Appl. No. 09/815,659
Amdt. Dated September 20, 2004
Reply to Office Action of May 18, 2004

DRAWING AMENDMENTS

FIG 11

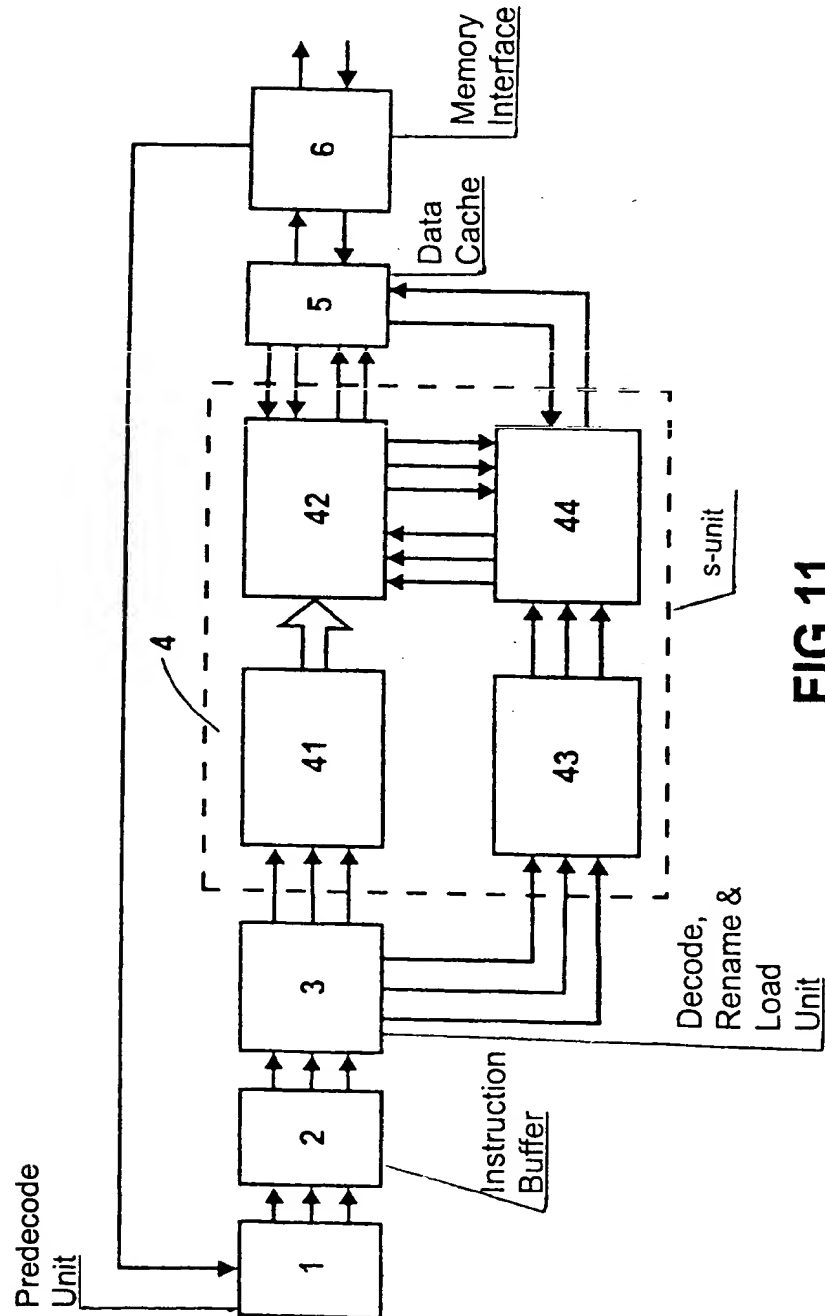
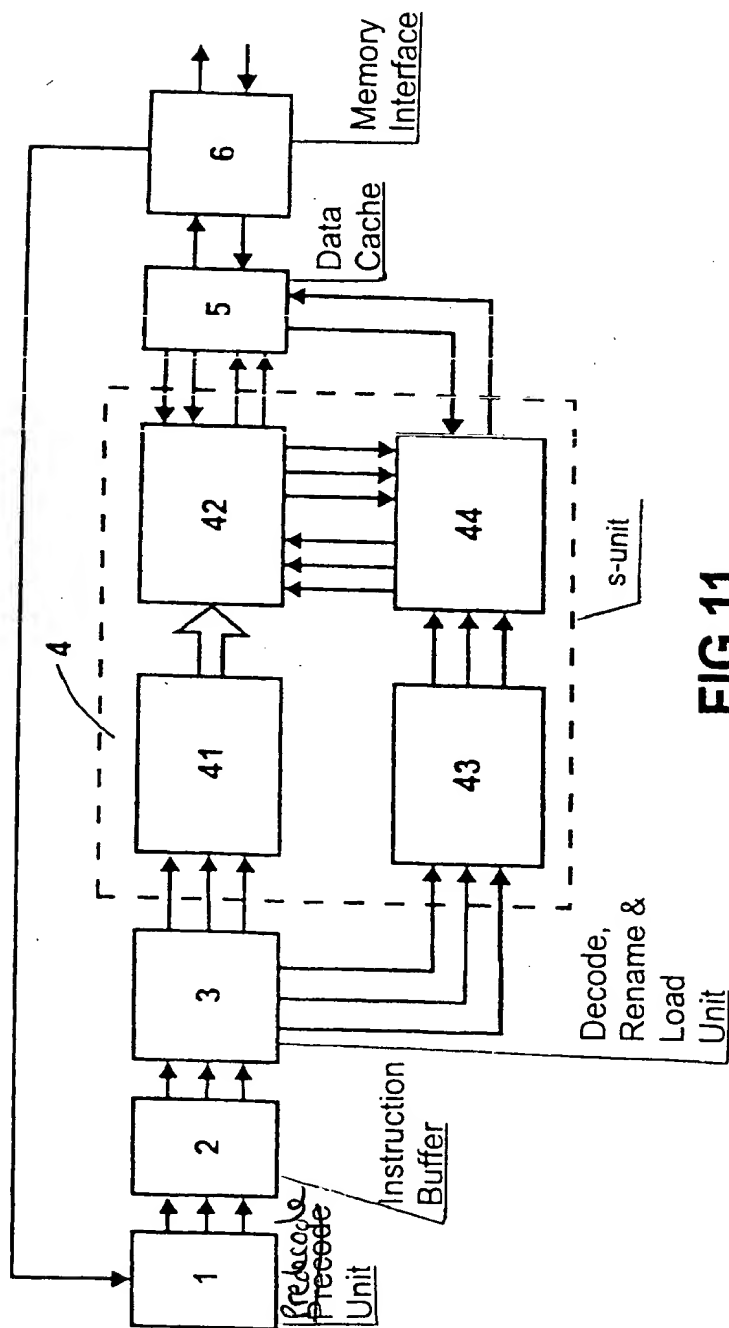
The attached sheet 7 of drawings includes changes to Fig. 11. Sheet 7, which includes Fig. 11, replaces the original sheet 7 including Fig. 11. In Fig. 11, the "Precode Unit" was relabeled as "Predecode Unit" with reference to element 1.

Please approve the drawing changes that are marked in red on the accompanying "Annotated Sheet Showing Changes" of Fig. 11. A formal "Replacement Sheet" of amended Fig. 11 is also enclosed.
